**TO:** T10 Membership  
**FROM:** Paul A. Suhler, Quantum Corporation  
**DATE:** 12 September 2006  
**SUBJECT:** T10/05-049r6, SSC-3 Physical Device Model

Figure X – UML description of physical device

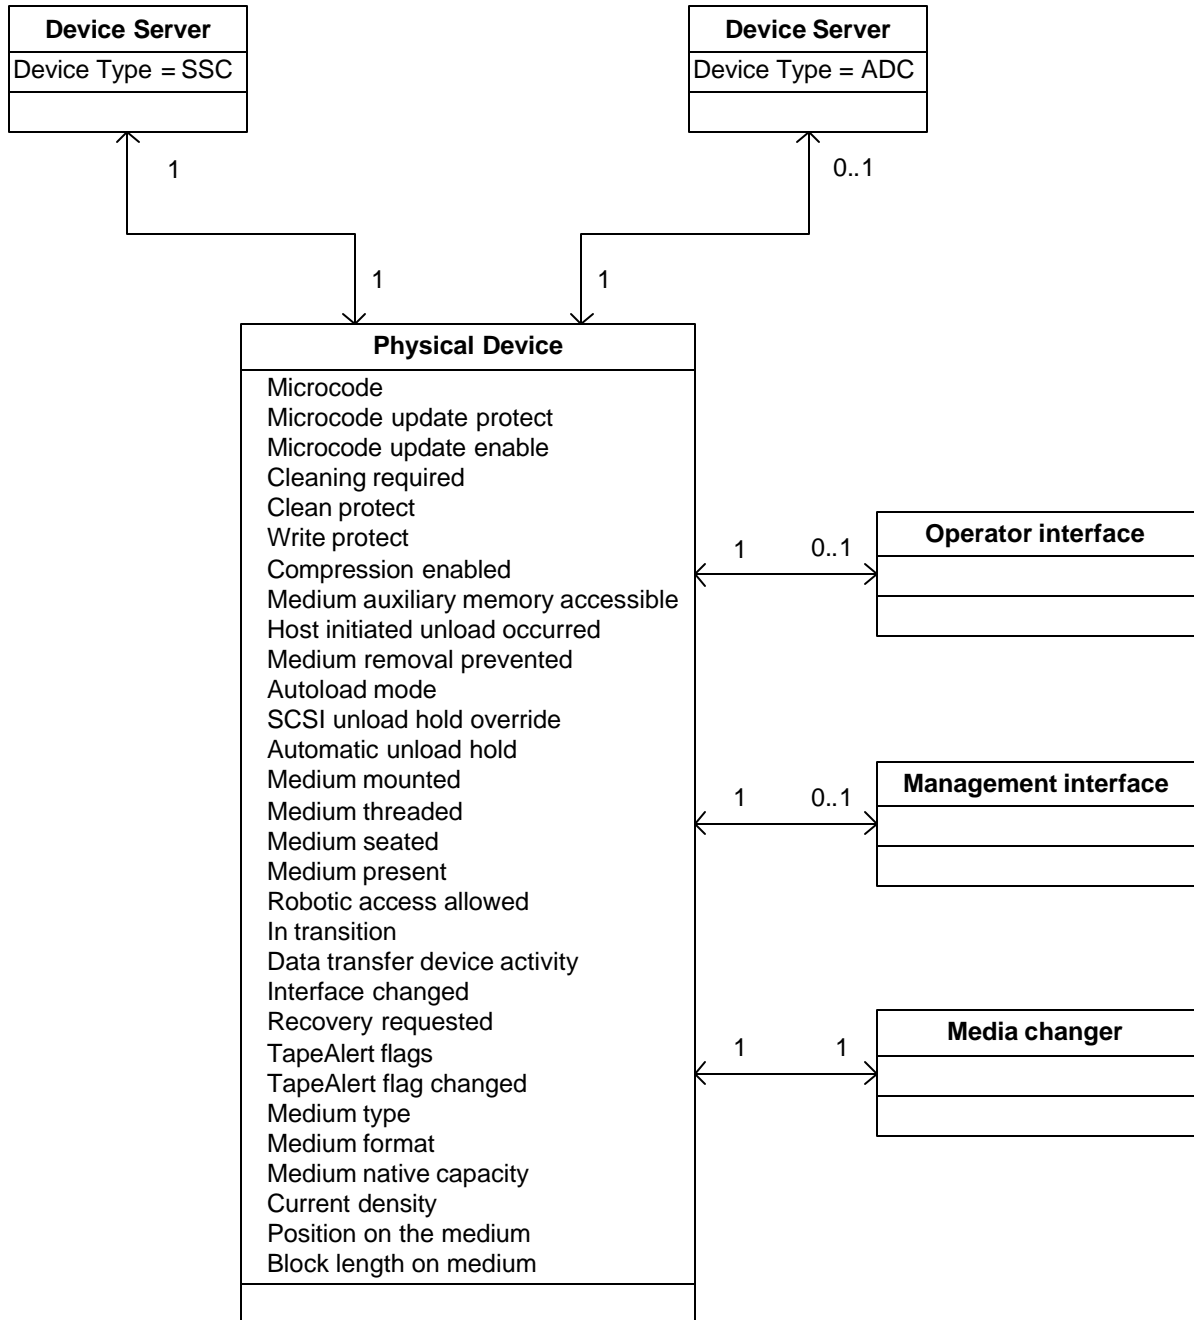
These entities perform operations that change various attributes of the physical device. These attributes affect the operations on a volume. Figure X shows in UML notation an example of the entities in a SCSI target device, and shows the attributes which comprise the physical device.
